# Planning Commission Staff Report June 11, 2015

CRC Oil and Gas Project  
Case No. PL13-0150

Approval Letter for CUP No. PL13-0150

Subject: Planning Director Decision Regarding  
Minor Modification of a Conditional Use Permit (CUP):  
Vintage Oil and Gas Facility  
Case No. PL13-0150  
10000 Ojai-Santa Paula Road, Santa Paula  
Assessor's Parcel Numbers 040-0-010-260, 040-0-210-080, 040-0-210-  
200, 040-0-060-055, and 040-0-210-070

*Graffiti is found at several locations within Drill Sites 1 and 7, in violation of permit conditions.*

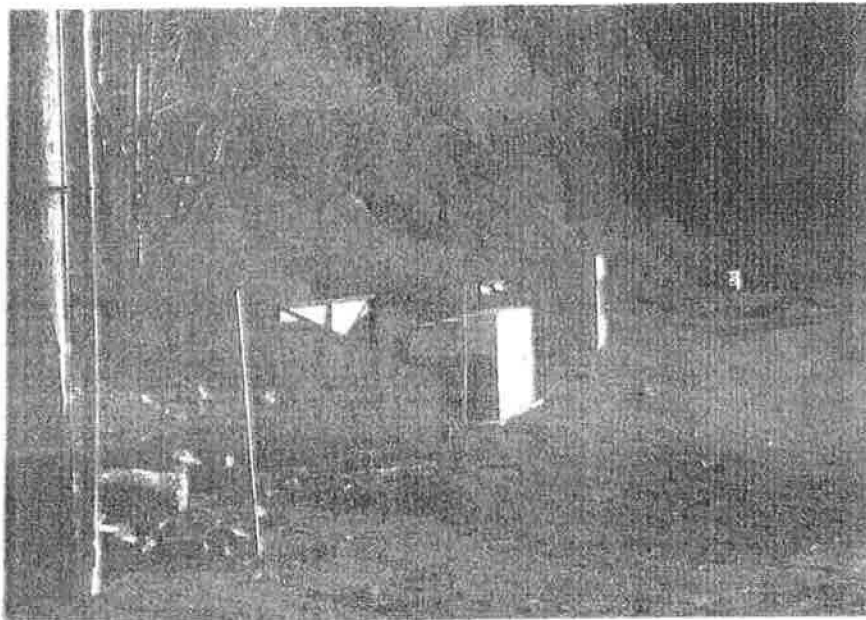
As another example, Condition 32 requires that the permit area "shall be maintained in a neat and orderly manner so as not to create any hazardous or unsightly conditions." But graffiti – visible from the trail – mars many of the facilities on Drill Site 7.

*Locked gate left open without any oil personnel present, in violation of permit conditions.*

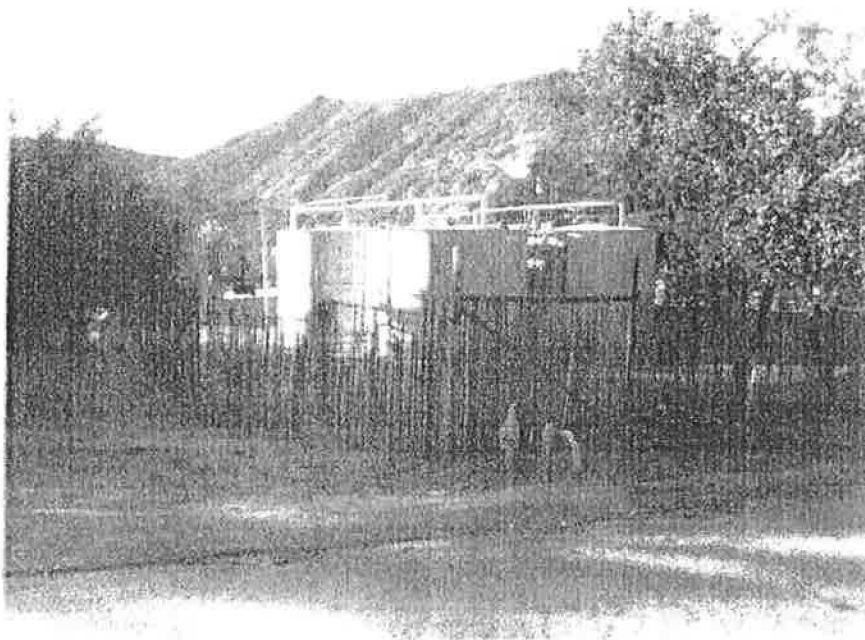
As a third example, Condition 49 requires that Drill Site 1 and Drill Site 7 "shall be completely enclosed by two (2) inch mesh chain link fence of a non-rusting material, constructed to a height of not less than six (6) feet and containing no openings except those required for ingress and egress." This condition also requires the gates to be kept locked "except when oil field personnel are present on the drill site." On our visit to these drill sites on January 5, 2015, the gate to Drill Site 7 was wide opened and unlocked, with absolutely no oil field personnel present.

*Wells visible from the public trail along Drill Site 1.*

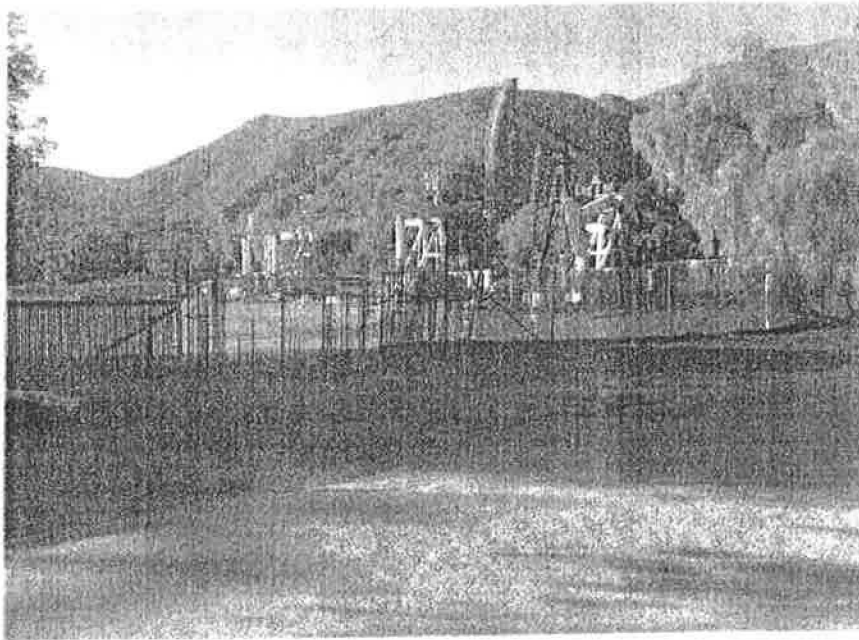
While the fence surrounding Drill Site 1 does have wooden slats, many of them are broken or missing. In addition, the fence is several feet too short to screen views of this drill site from the adjacent trail. Trail users can view the site's wells and tanks along virtually the entire length of the adjacent trail segment, with the exception of a few areas that are screened by mature trees. To immediately comply with this permit condition, Vintage must repair the wooden slats and install vegetation to "fully screen" this site. Vintage should also consider removing the out-of-service tanks at this site, consistent with state law. The EIR Addendum fails to address this matter, and a Subsequent EIR must be prepared.

<p>Coastal Zoning Ordinance are addressed in the Planning Director staff report for the January 8, 2015 hearing.</p> <p>This comment does not provide substantial evidence of a new potentially significant impact.</p>
G	G-14	<p>The components of the proposed project are not visible from public roads included in the County Regional Road network. The commenter is correct in that the components of the project that would be located on Drillsites #1 and #7 will be visible from the public trail that extends from State Highway 150 through the St. Thomas Aquinas campus and into Santa Paula Canyon.</p> <p>Planning staff disagrees that the placement of new oil wells at the two drillsites (#1 and #7) visible from the trail will substantially alter scenic views adjacent to the existing oil field facilities. These existing sites are currently characterized by operating oil wells, tanks and other facilities. This character would not substantially change with the addition of new oil wells. The components of the project that would be located on Drillsites #2 and #3 will not be visible from public viewing areas.</p>

*Drill Site 7 is completely visible from the public trail, in violation of permit conditions.*

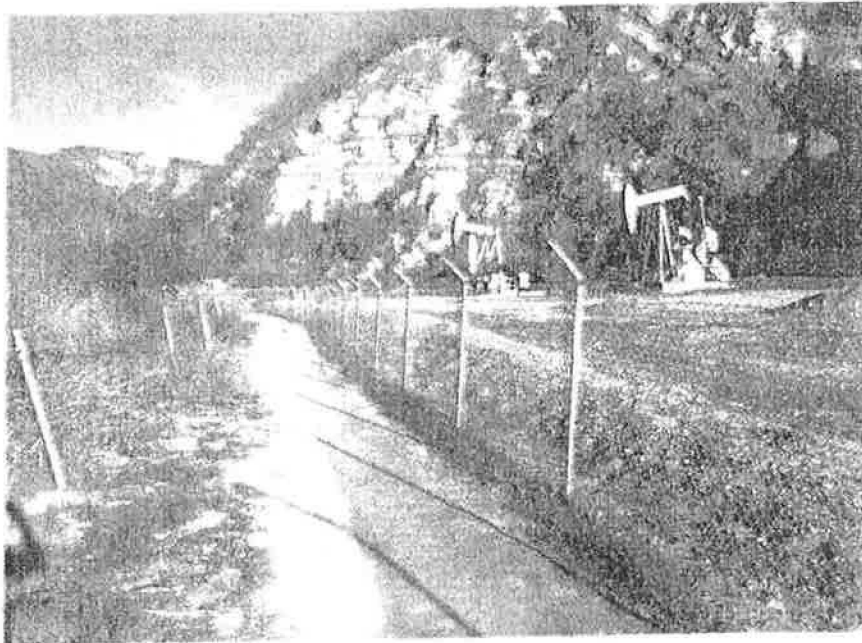
Moreover, Vintage has not attempted to undertake any measures to screen Drill Site 7 along Santa Paula Creek from trail users' views. The chain link fence is transparent without any wooden slats. Several areas along the fence provide ample space for landscaping. In order to fully comply with the plain terms of this permit condition requiring landscaping to "fully screen" all equipment, Vintage should consider moving the chain link fence to allow additional space for landscaping between the fence and the trail. Vintage claims that this is not feasible because vegetation would encroach on the wells and present an undue fire risk. However, proposed Condition 68 only requires a thirty-foot vegetation clearance for fire prevention, leaving ample room to accommodate vegetative screening. The EIR Addendum does not address this matter, and a Subsequent EIR must be prepared.

landscaping and screening measures that will minimize visual effects. The vegetation included in the required landscaping will be comprised of native species.
G	G-18	There will be no change in the current public hiking trail as a result of the proposed project. Thus, there will be no new impact on public recreation. The proposed project will be conditioned to require cooperation by the Permittee with other interests to establish a permanent hiking trail.
G	G-19	Refer to response to comment C-2.
G	G-20	Refer to response to comment D-1.
G	G-21	<p>The July 18, 2013 letter to the Ventura County Planning Director from the US Fish and Wildlife Service (USFWS) provides a list of 23 recommended measures to "protect the condor from the potential adverse effects of oil and gas projects." The USFWS letter states that <i>"we are writing to provide you with information that we recommend considering during project review."</i> The letter further states that <i>"we understand that each oil and gas project is unique and every measure will not be applicable to all project."</i> Thus, the USFWS recognizes that the 23 listed measures are not laws or regulations but recommendations from agency staff to be considered by the local land use authority in the review of oil and gas projects.</p> <p>All of the onsite operational measures (measures 2 through 23) recommended by the USFWS in the 7-18-15 letter have been incorporated into the conditions of approval. The commenter asserts that USFWS recommendations #19 and #21 have been omitted from the recommended conditions of approval. This is incorrect. USFWS recommended measure #19 involves fire protection and is incorporated into condition of approval #69. USFWS recommendation 21 is included in condition of approval #34r.</p> <p>As pointed out by the commenter, the first of the 23 USFWS recommended measures states that <i>"oil and gas facilities will not be developed within 1.5 miles of active and historic nest sites and reintroduction sites, or within 0.5 miles of an active roost site."</i> This recommendation is not a mitigation measure that applies to a specific project but instead constitutes a proposed land use policy. Such a policy has not been codified in State or Federal law and has not been adopted by the County of Ventura.</p> <p>California condors are known to fly over most of Ventura County, including the Santa Paula Creek area in the vicinity of</p>
